Creaking/Cracking Noise from the Upper Roof Area

| R60 (Cooper, Cooper S Countryman) |
| Produced from July 31, 2011 |

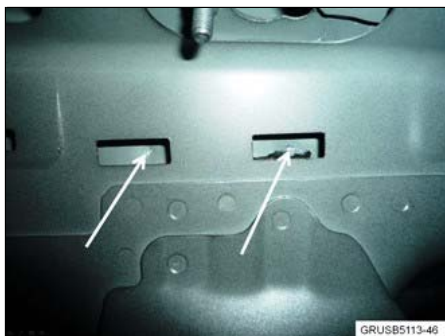
3. Road test the vehicle with a helper, inserting a screwdriver through the roof, and opening and

applying varying pressure to the metal roof support as shown. If the noise can be eliminated by applying pressure, proceed to the next step
